**RFQ 191002
Sequim Solar PV Project**

ADDENDUM NO. 1

**PUD #1 of Clallam County
P.O. Box 1000
Carlsborg, WA 98324**

April 30, 2019

Grounding Specification

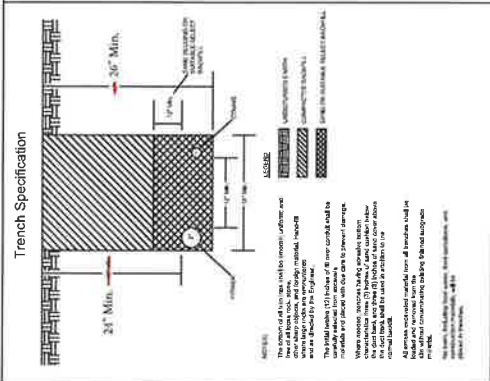
Page 3 of 6 Grounding Specification: Note added "Racks that have grounding connections integral to racking system do not require additional lay in lugs."

1. Are lay in lugs required or can rack integrated ground connections be used?
2. Can solar panels be oriented differently? **Yes, the panels can be mounted in portrait or landscape.**

Trench Specification

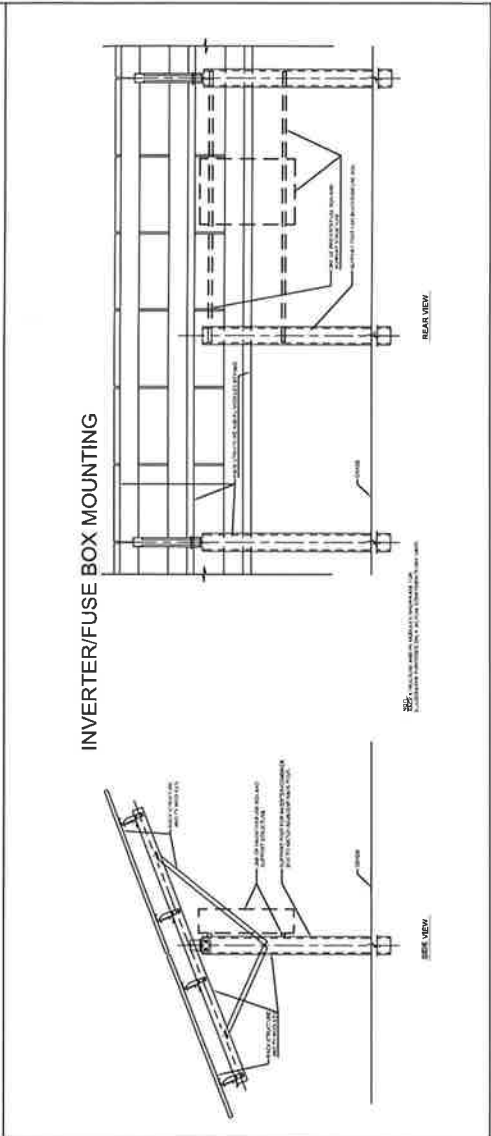
Page 3 of 6 Trench Specification: Minimum fill above top of pipe changed from 30" to 24". Minimum depth to bottom of trench changed from 42" to 26".

CONDUIT FEEDER RUNS - SEQUIM SUB

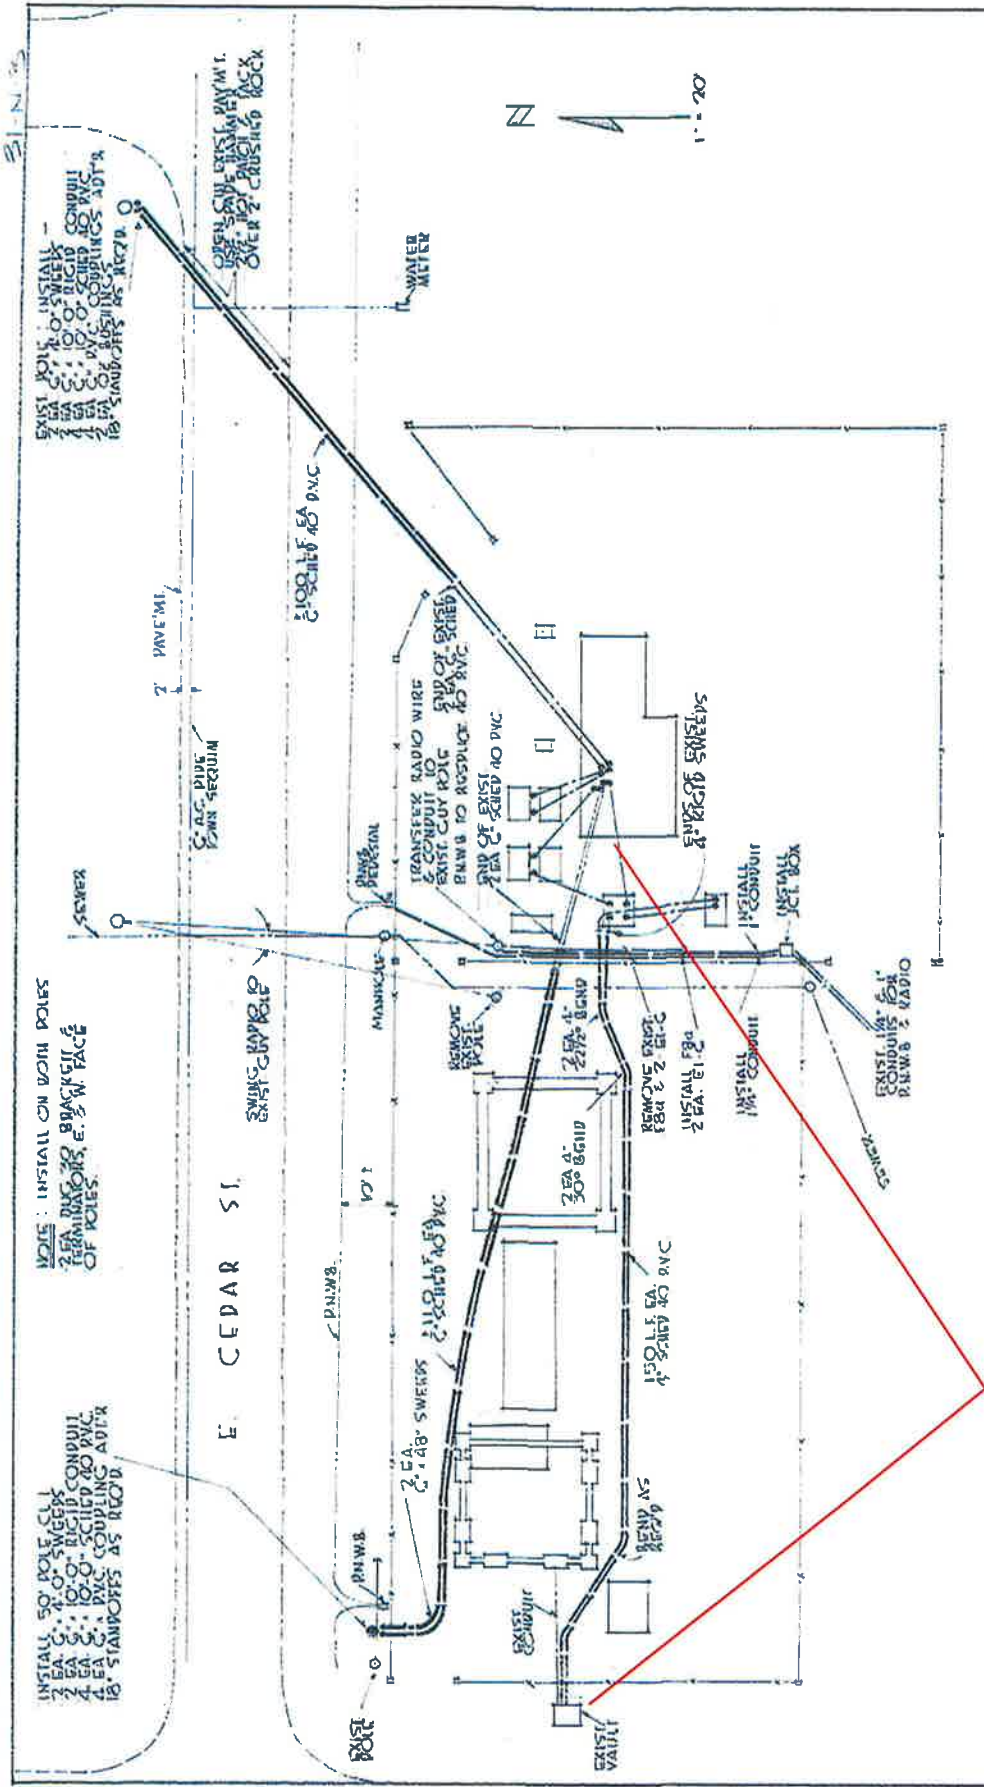
A drawing of the substation that shows conduits for primary power and a presumed communication cable will be attached. Please be aware that this drawing is from 1980 and may not be accurate.

Communication cable in conduit run between vault and Control Building. Exact location unknown.
